## FAQ Log 11/17/05

TempNo.	PI	Topic	Status	Plant/ Co.
54.1	MS1-4	Exemption of overhaul hours	5/19 Introduced 7/21 Discussed 8/18 Discussed 10/19 Discussed	Catawba
55.1	MS01	Planned unavailable hours	7/21 Introduced 8/18 Awaiting licensee revision 10/19 Revised by Licensee to reflect comments 10/19 Discussed	TM11

Browns Ferry Unit 1/Unit 2 safety-related 4160 electrical distribution single line

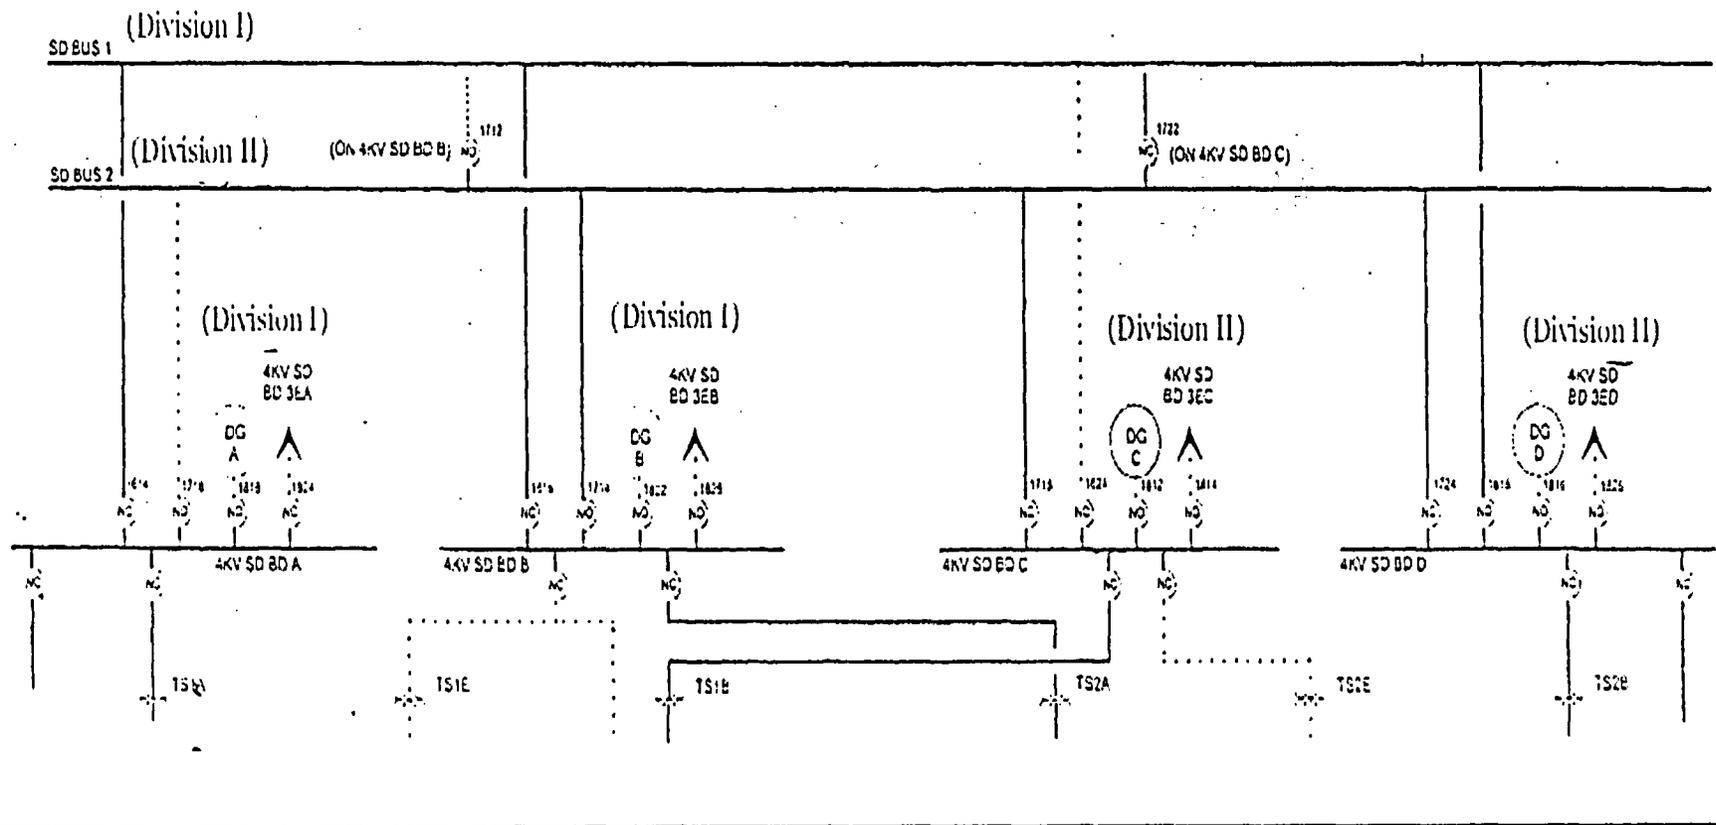
Browns Ferry Unit 1 is being recovered from an extended shutdown. Recovery efforts include replacement of cables to the Division I and Division II Emergency AC (EAC) power. The cables are being replaced in order to provide qualified cables (including requisite documentation) to meet current Environmental Qualification, Post Accident Monitoring, Voltage Drop/Ampacity/Short Circuit requirements, Appendix R, Electrical Separation and to address breakage as identified by electrical calculations.

The Division I and Division II EAC for Units 1 and 2 each contain 2 Emergency Diesel Generators and 2 4160v Shutdown Boards with each Emergency Diesel Generator and Shutdown Board supplying approximately 50% of the emergency power required for each Division EAC. The Emergency Diesel Generators and Shutdown Board are paired as A & B in Division I and C & D in Division II.

To replace these cables, Emergency Diesel Generators A, B, and D and 4160v Shutdown Boards A, B and D will be removed from service one train at a time. The work is planned such that when

A Emergency Diesel Generator and 4160v Shutdown Board A are out of service, the B, C, and D Emergency Diesel Generators and B, C, and D 4160v Shutdown Boards will remain available. Also when the B or D train is out of service the other three trains will remain available. The work to replace the cables on any one of the trains can be done within the Tech Spec AOT of 14 days for the Emergency Diesel Generator.

The effect of the Browns Ferry Nuclear (BFN) Unit 1 Emergency AC (EAC) power restoration activities on Unit 2 and Unit 3 system unavailabilities is a unique condition that had not been anticipated during the development of the PI guidance document. The unavailability of the Unit 2 and Unit 3 systems due to the Unit 1 EAC restoration work does not truly reflect the performance of the Unit 2 and Unit 3 systems. For this unique, one-time-only activity, the planned BFN Unit 1 EAC restoration may be treated similar to "Planned Overhaul Maintenance." That is, if additional time is needed beyond the original schedule duration to repair equipment problems discovered during the restoration activities, the additional hours would count toward the indicator. In addition, other activities may be performed with the restoration activity as long as the outage duration is bounded by the restoration activities. If the restoration activities are complete, and the outage continues due to non-restoration activities, the additional hours would count toward the indicator.
